# Access Compliance Report

## Public Rights-of-Way

### (Curb Ramps)

Intersection ID: 2609	Main Street: ANZACK_LN	Cross Street: HARTFIELD_DOWNS_DR	Location: NW
ADA ID: 0D8793173269	Ramp Type: Perp	Initial Pass/Fail: Fail	Overall Compliance: No
Severity Score: 37.5			
Codes/Mitigation Info/Possible Solution		Field Measurements/Component Compliance

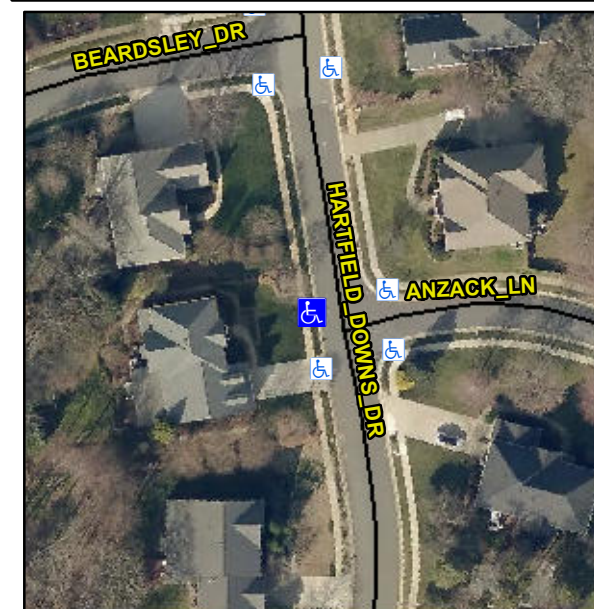
**Not Found, R304.2.2, R304.5.3**

Compliance	Description	Data	Compliance	Description	Data
N/A	Ramp Length (in)	46.0	No	Ramp Slope (%)	15.0
Yes	Ramp Width (in)	48.0	No	Ramp XSlope (%)	6.4
N/A	Flare Type LT	N/A	N/A	Flare Type RT	N/A
N/A	Flare Slope LT (%)	N/A	N/A	Flare Slope RT (%)	N/A
N/A	Flare Traversable LT?	N/A	N/A	Flare Traversable RT?	N/A
N/A	Landing Length (in)	N/A	N/A	DWS Provided?	N/A
N/A	Landing Width (in)	N/A	N/A	DWS Contrast?	N/A
N/A	Landing Slope (%)	N/A	N/A	DWS Length (in)	N/A
N/A	Landing X Slope (%)	N/A	N/A	DWS Full Width?	N/A
N/A	Landing Curb? (Y/N)	N/A	N/A	DWS Offset (in)	N/A
N/A	Shared Landing?	N/A			
N/A	Gutter Ponding?	N/A	N/A	Gutter Slope (%)	N/A
N/A	Gutter Lip Ht (in)	N/A	N/A	Gutter X Slope (%)	N/A
N/A	Painted X Walk1?	No	N/A	Painted X Walk2?	N/A
	X Walk 1 Direction	To E		X Walk 2 Direction	N/A
N/A	X Walk 1 Width (in)	N/A	N/A	X Walk 2 Width (in)	N/A
	X Walk 1 Slope (%)	1.7		X Walk 2 Slope (%)	N/A
	X Walk 1 X Slope (%)	7.3		X Walk 2 X Slope (%)	N/A

**Remove & Replace Entire Ramp.**
